DESCRIPTION OF REQUEST: Final Sign-Off for EPC Approved Site Development Plan for Subdivision

**RE: WYOMING AND MONTGOMERY
SITE DEVELOPMENT PLAN FOR SUBDIVISION
PROJECT 1010550/ 15EPC-40032**

Project# 1010550
15EPC-40032 Site Development Plan for Subdivision

A4 SITE PLAN
1" = 50'-0"

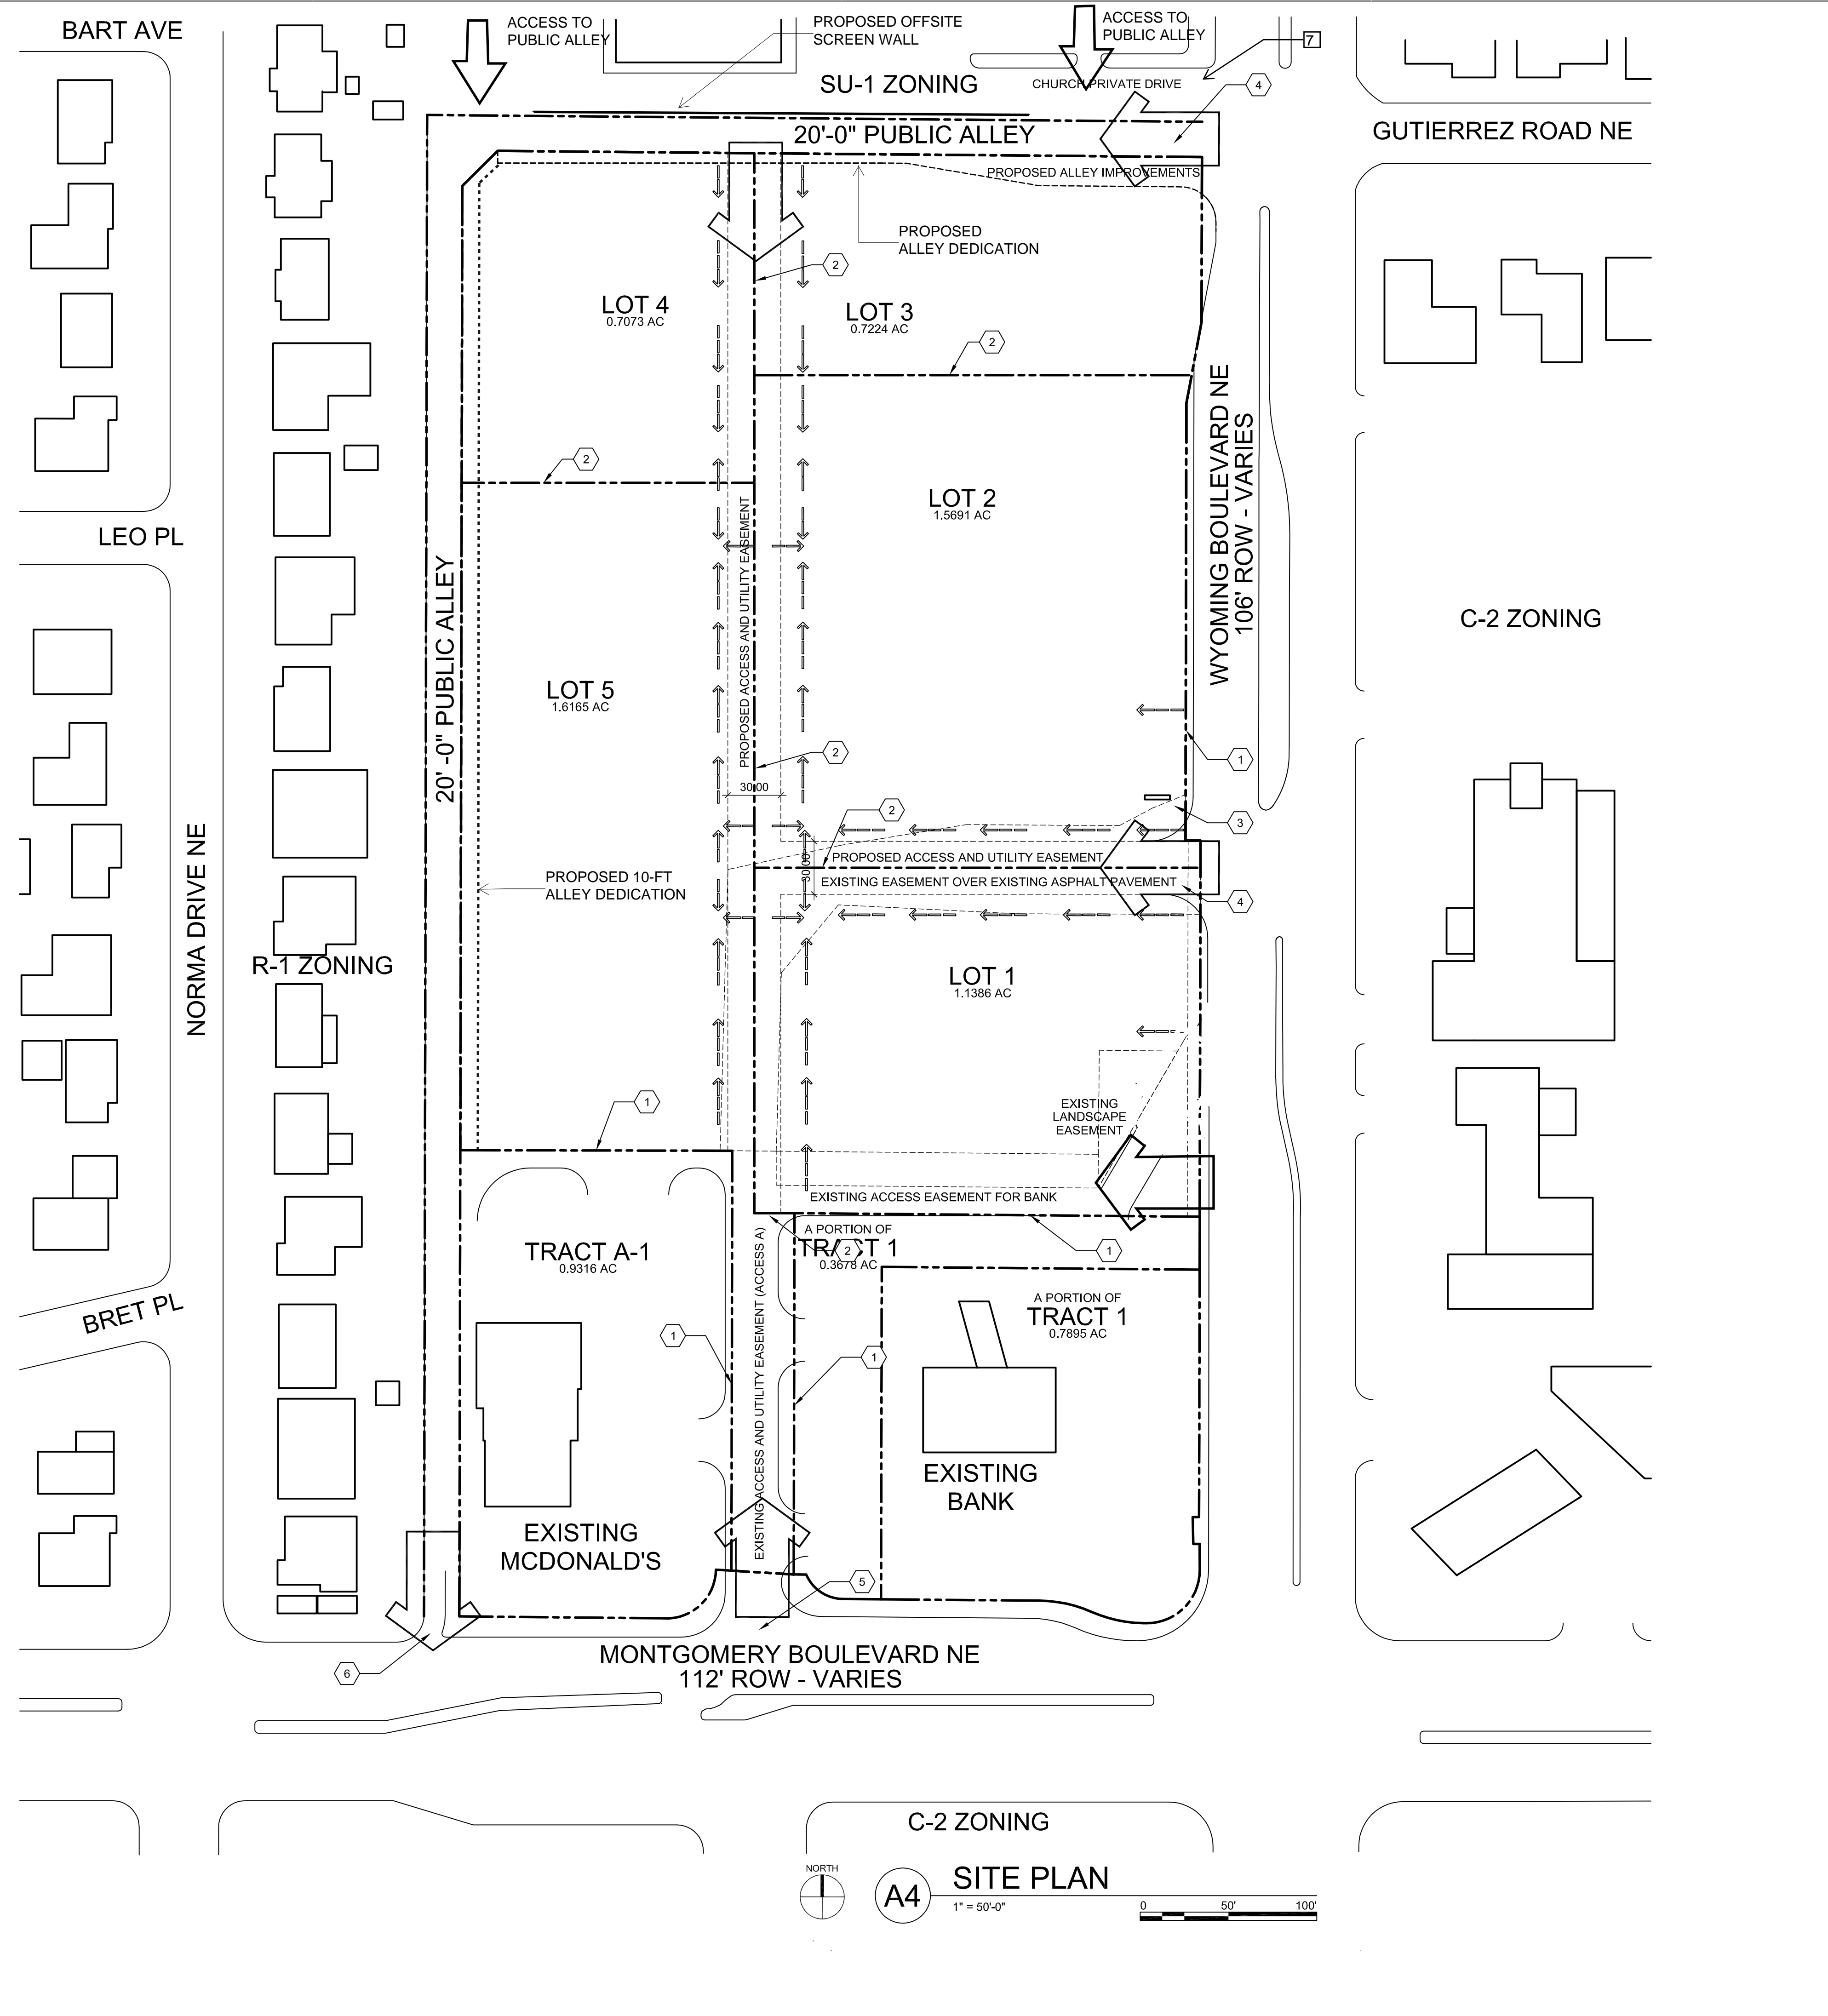
- The existing access (located on the SE corner of the property) to the Bank parcel needs to be modified to be perpendicular to the roadway.

RESPONSE: The access has been modified to show as perpendicular to the roadway in accordance to the TIS.

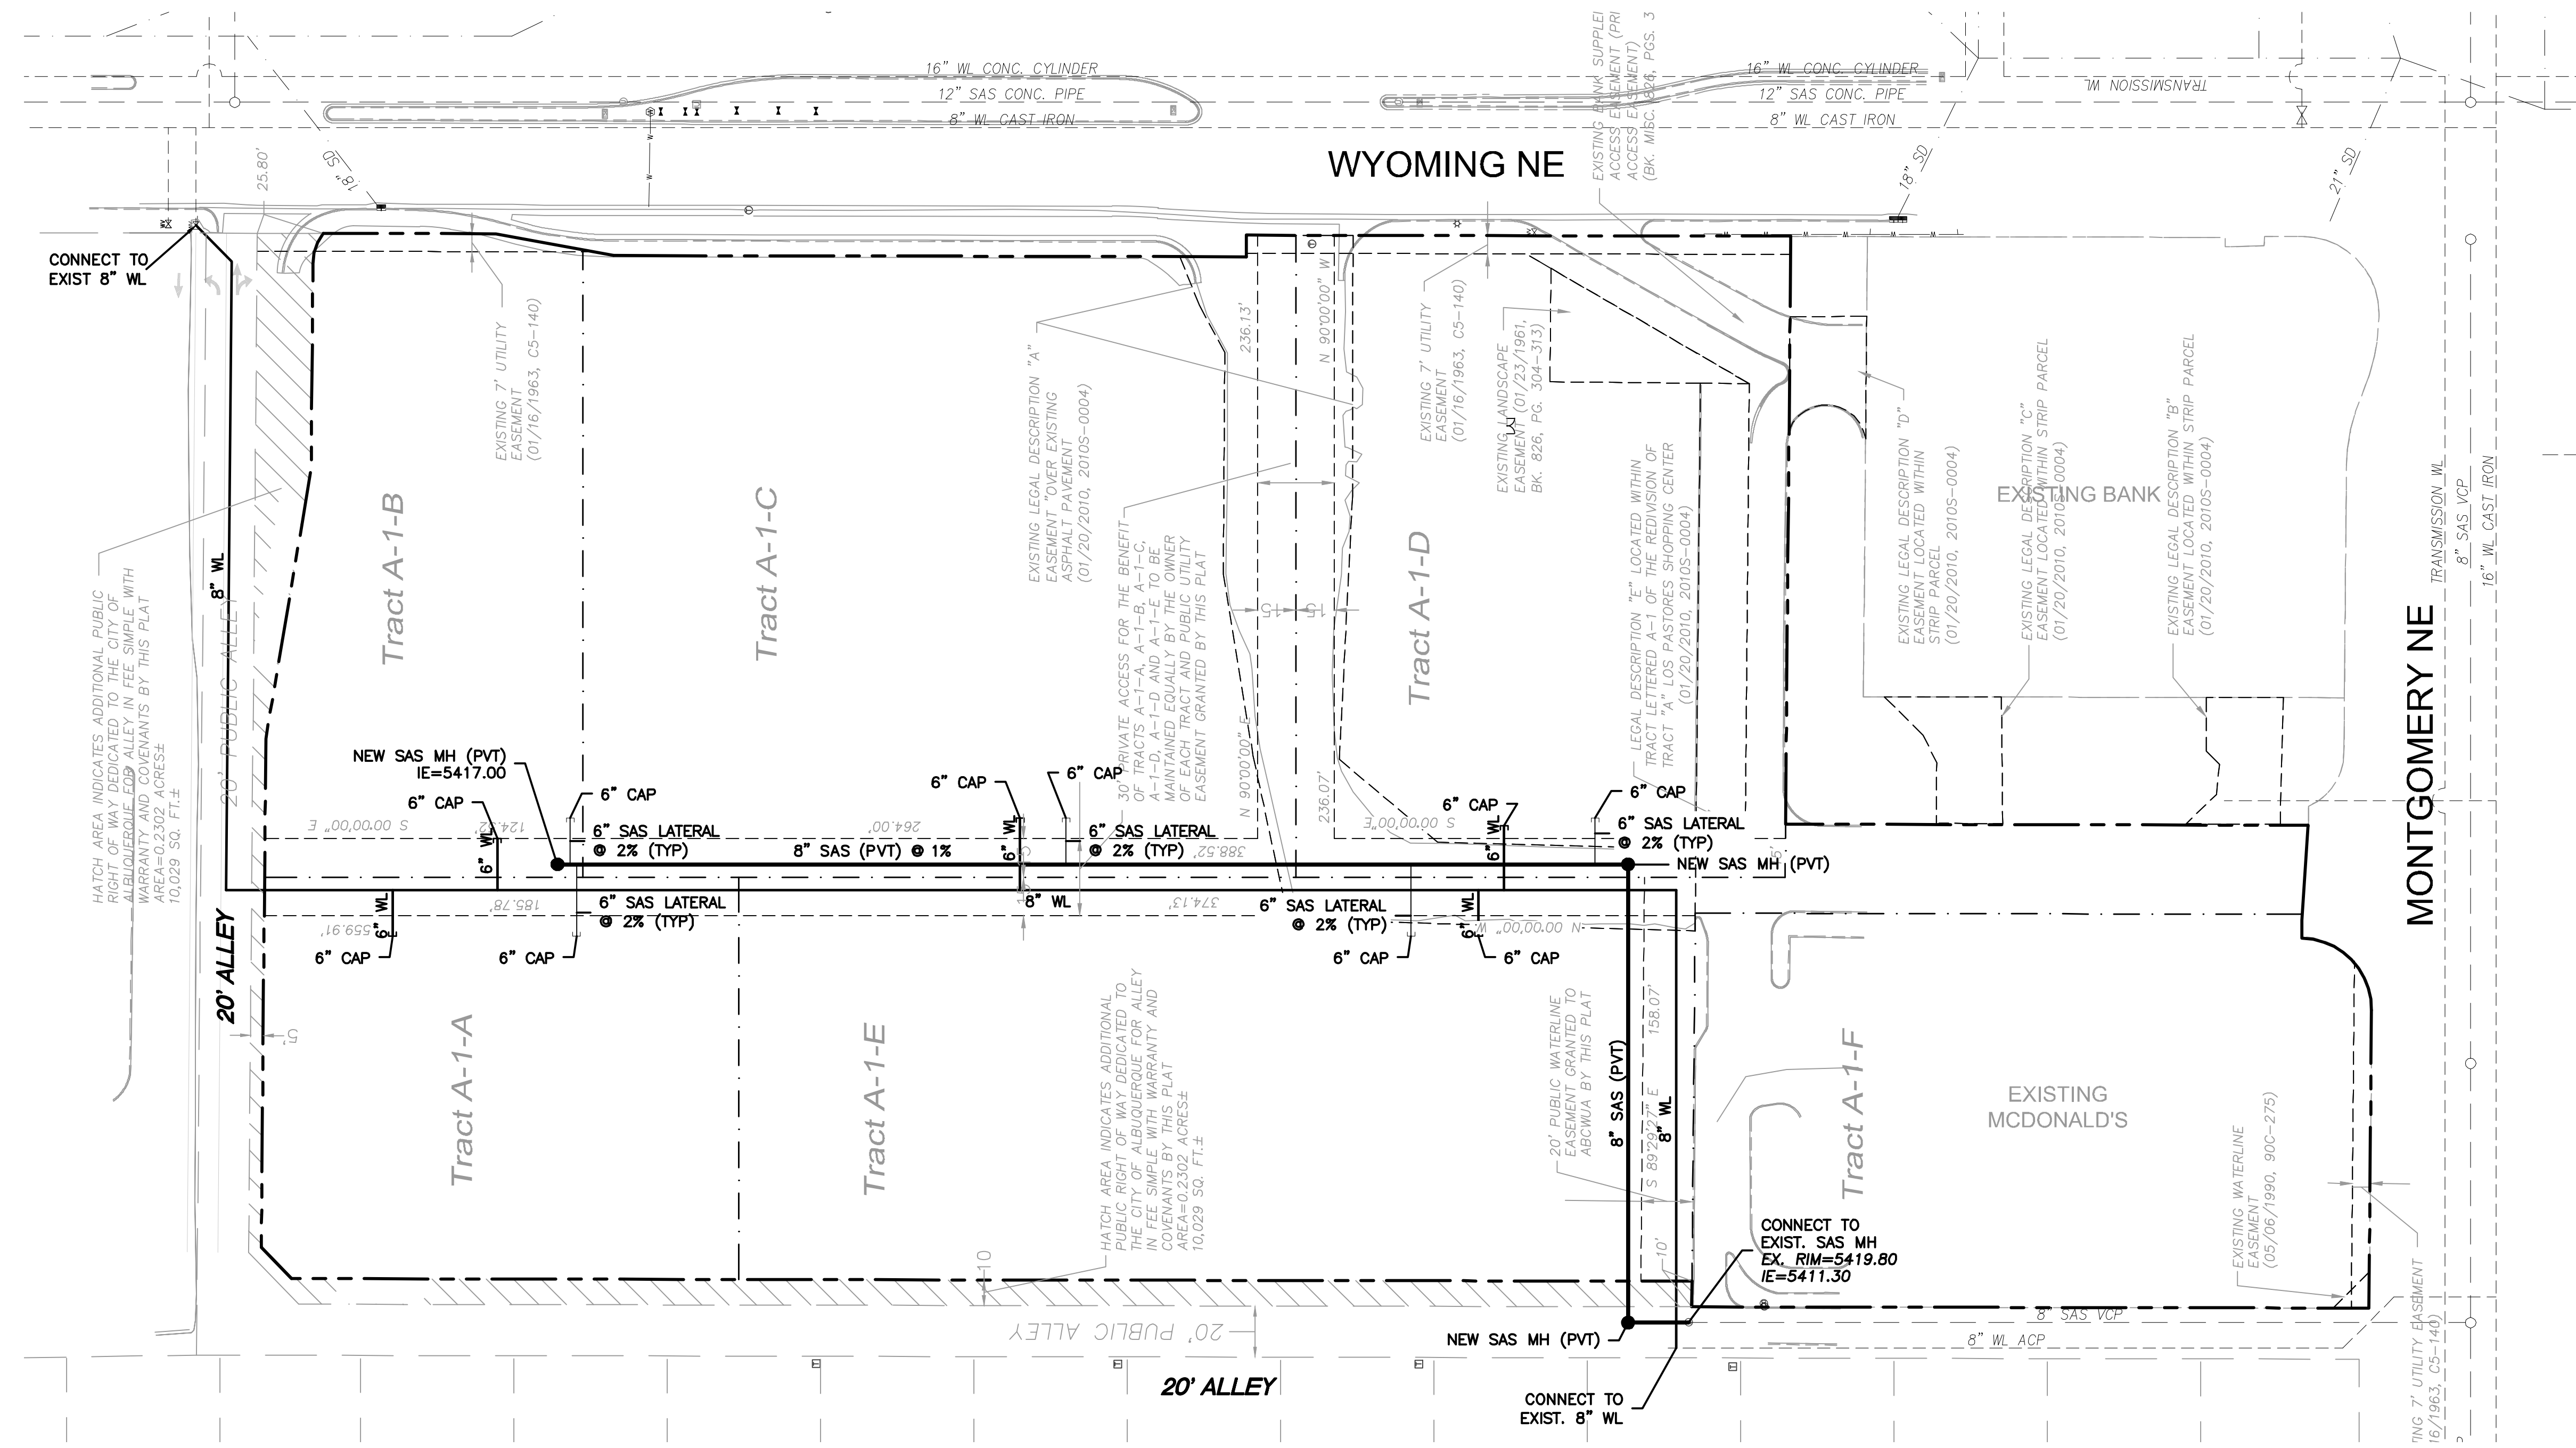
- The Utility Plan indicates public sanitary sewer onsite. This will not be acceptable.

RESPONSE: The plan was modified to designate the proposed sanitary sewer system as private.
